Review and Evaluation of the Millstone Unit 3 Probabilistic Safety Study

Containment Failure Modes, Radiological
Source-Terms and Offsite Consequences

Prepared by M. Khatib-Rahbar, W. Pratt, H. Ludewig/BNL
R. Barrett, P. Easley/NRC

Prepared for
Division of Systems Integration
Office of Nuclear Reactor Regulation
U.S. Nuclear Regulatory Commission
Washington, D.C. 20555
NRC FIN A3748

Figure 3.2 Containment Failure Pressure Distribution for Millstone-3

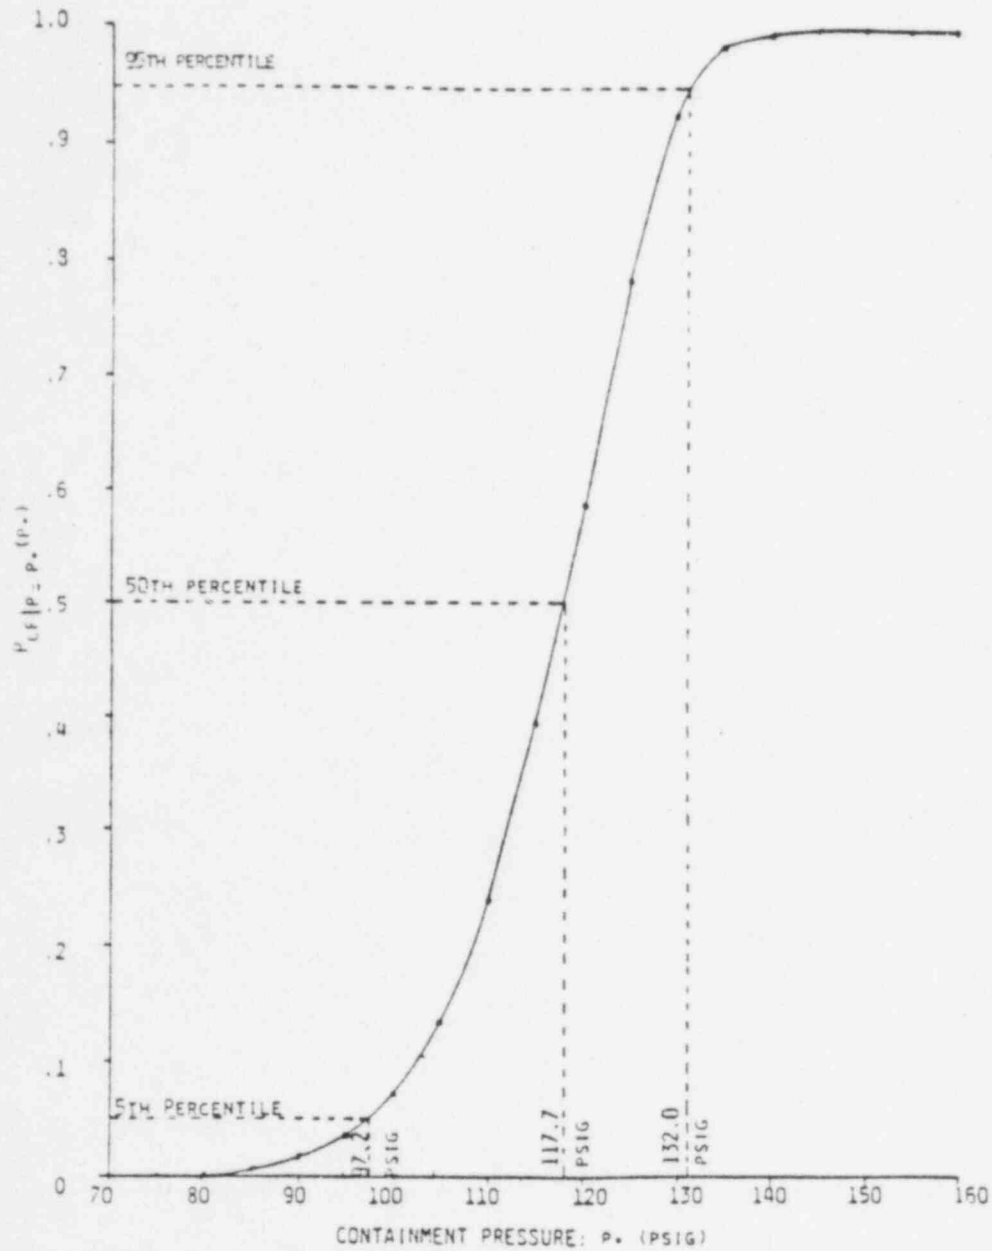
An additional source of uncertainty is the distribution function used by the applicant to describe the containment failure pressures (see Figure 3.2). There is concern that the low pressure end of the distribution gives undue weight to the possibility of failure at pressures below 100 psia. We have examined the dominant containment failure modes and found that variation of the failure pressure distribution within reasonable limits would not appreciably affect our risk estimates.

Figure 7.1 Cost and Benefit Estimates and Uncertainty Ranges of Mitigative Features Which Would Provide Protection for (a) Non-Seismic Overpressure Failure and Hydrogen Burns, and (b) Seismically Induced Overpressure Failure.

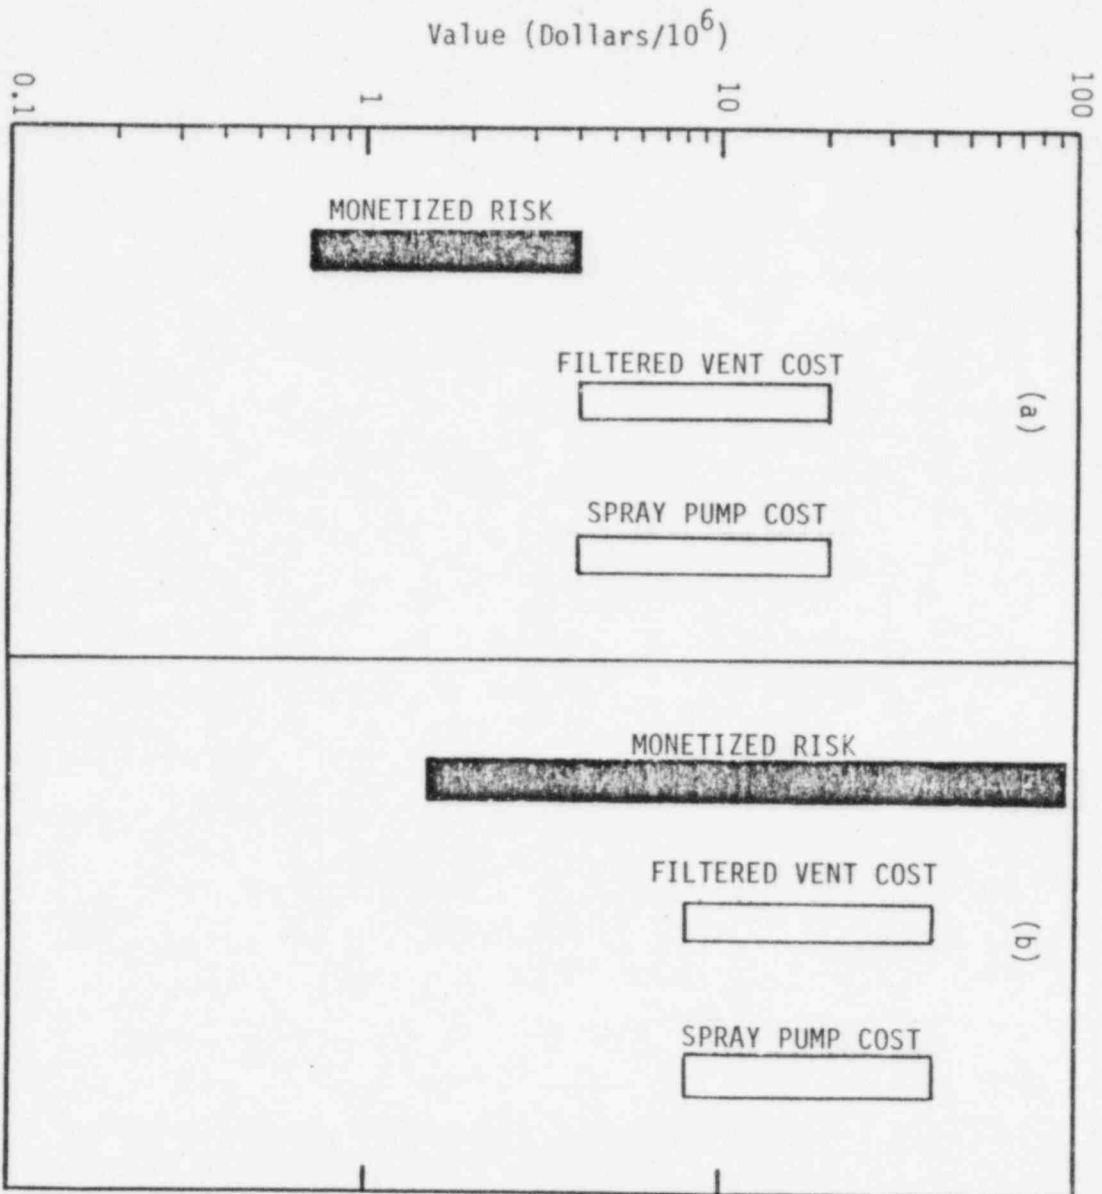
The risk reduction achievable would be the sum of seismic and non-seismic events for both the M6 and M7 release categories (Table 7.1). These estimates range from a low value of 40 person-rem per reactor year based on the PSS hazard curve and including only the risk within 50 miles of the plant, to 2260 person-rem per reactor year for the SHCP hazard curve including risk within 350 miles. The monetized values of those risk estimates are \$1.6 million and \$90 million, respectively, are plotted in Figure 7.1b.

The comparison of costs and benefits in Figure 7.1b indicates that either of the two mitigative fixes might be cost effective. This result prompted us to more closely examine the estimates of both cost and risk.

For a number of reasons, we have concluded that the risk estimates shown in Figure 7.1b are greatly overestimated. First, a reduction of about a factor of two was obtained by reexamining the seismic fragility of some key components. One important failure point, the diesel generator room footings, were found to have been evaluated too conservatively. Another weakness, the bolts on the diesel generator oil cooler, could be eliminated with an inexpensive design change which the staff intends to recommend.

More importantly, for reasons discussed in Sections 6.2 and 7.2.1, we are confident that the radiological releases have been overestimated by an order of magnitude or more. This conclusion is based on results of the revised NRC source term methodology.
